Date: 08/08/2014
To: LT Series Light Towers Owners
From: Multiquip Product Department
Subject: Snap Rings Replacement — **Mandatory Update**

LT Series Snap Ring Replacement

Product Group: Light Towers	Date Issued: 08/08/14	Service Bulletin No.: LT20140728
---------------------------------------	---------------------------------	--

Figure 1. Location of Snap Rings

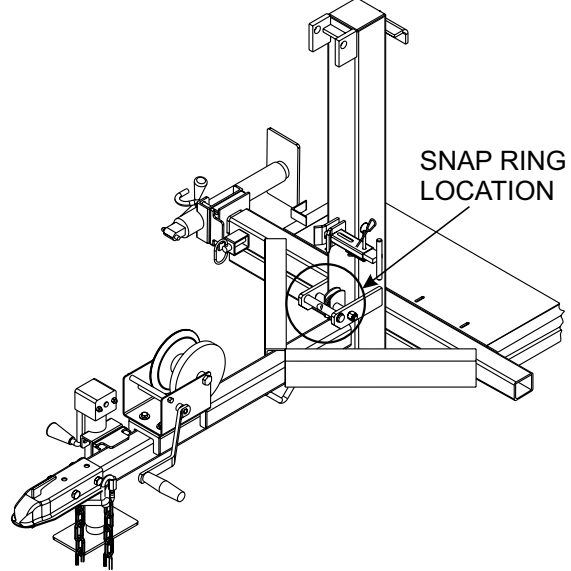
Problem: When the snap rings were installed on the line, the snap rings sprung. This is critical as the snap rings contain the pin that anchors the mast cable.

1. Inspect snap rings on both ends of the spring that anchors the mast cable on the light tower trailer. See Figure 1 for location of snap rings.

Solution: Replace snap rings. **Failure to perform this procedure may result in damage to mast assembly and/or damage to property or personal injury.**

Figure 2. Installation of Snap Rings

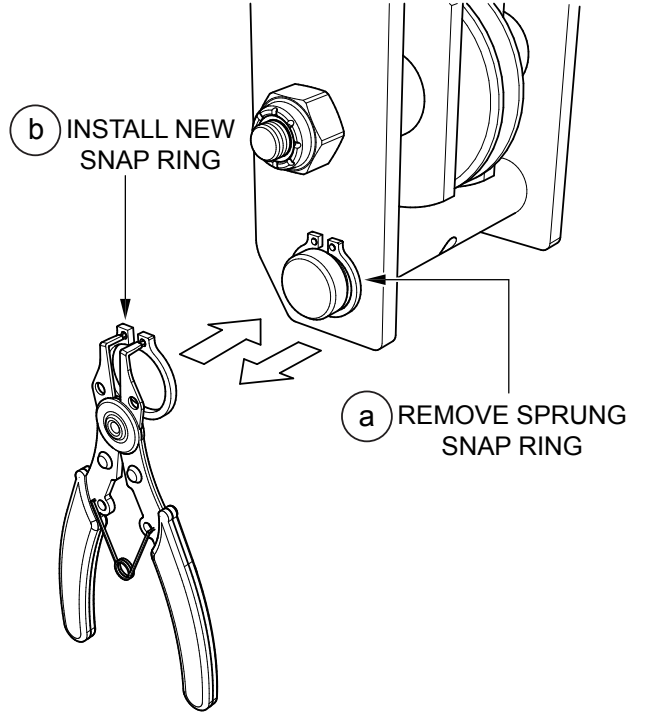
2. If snap ring is completely seated, replacement is not necessary.
3. If snap ring has sprung:
 - a. Remove the snap ring with a snap ring tool. See Figure 2.
 - b. Install new snap ring carefully with the snap ring tool. Ensure snap ring has seated completely within groove of pin. See Figure 2.
